**In the Matter of a Review of the Long-Term Gas  
System Plan of National Grid**

**Case 24-G-0248**

Initial Comments of  
Natural Resources Defense Council

**Date: September 18, 2024**

Figure 2. AE Scenario: System Volumes and Composition

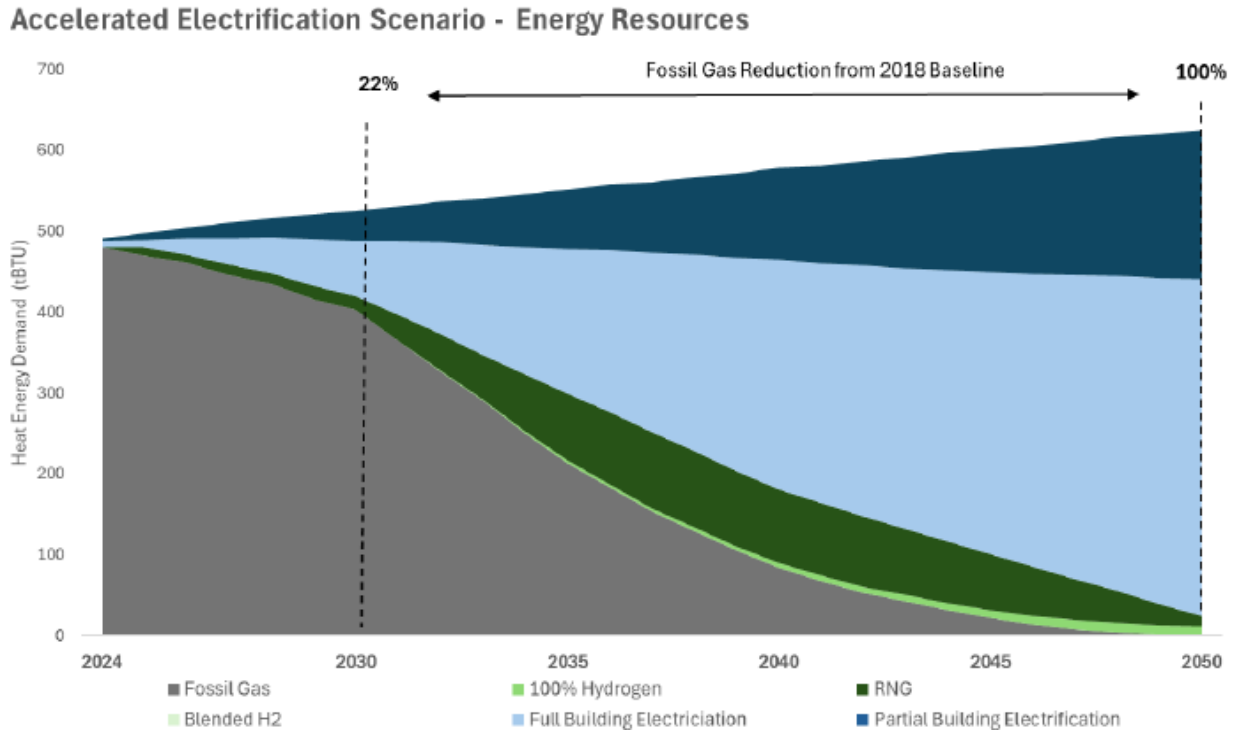
Note: In Response to discovery NRDC 60(a), National Grid explains an error in the LTP; the dark blue area at the top represents energy efficiency, not “Partial Building Electrification” as labeled.

Figure 3: 2024 In-State RNG Capacity compared to 2040 Limited/Optimistic Projected Capacity

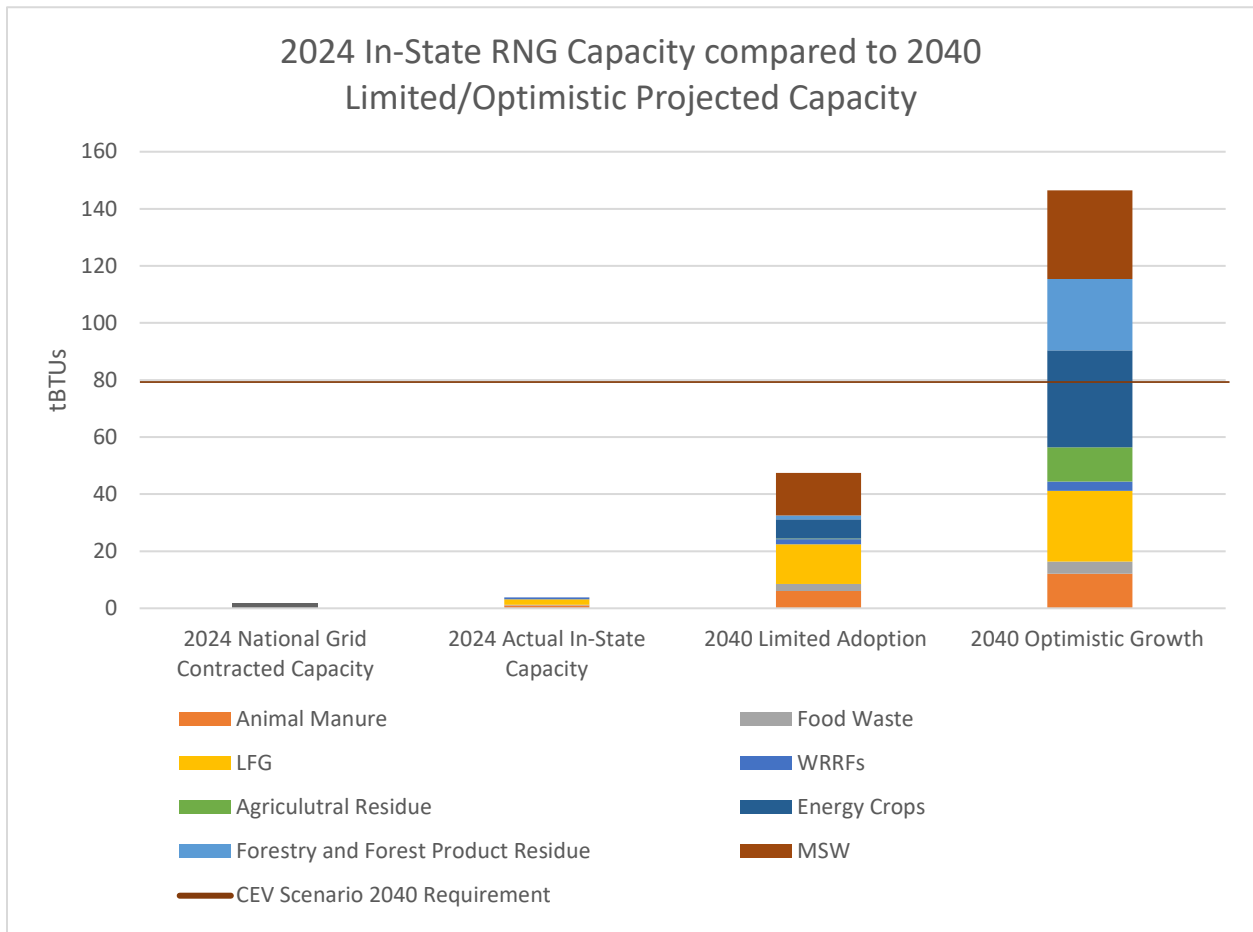
iii) **Unrealistic projected growth rates in in-state capacity:** To meet the total 2040 “Limited Adoption” potential of 47.4 tBTU estimated by the NYSERDA study, total project in-state RNG capacity growth must grow significantly (see Table 2). Meeting this projection would require scaling the state’s total RNG capacity by 11 times between now and 2040, an annualized growth rate of 77 percent per year. To meet the most ambitious “Optimistic Growth” trajectory, the state’s RNG capacity would have to grow 38 times over, or roughly 250 percent per year. While the technical potential in the state may allow for RNG growth approximating these estimated annual RNG production potential values, real-world growth rates are unlikely to match either the limited or optimistic growth trajectory. Figure 3 shows just how much in-state RNG capacity must grow between now and 2040 to meet the limited adoption and optimistic growth estimate in the 2022 NYSERDA report. The Companies have failed to provide any evidence to suggest that in-state RNG capacity will grow at the rates required to meet either the limited or optimistic adoption cases.
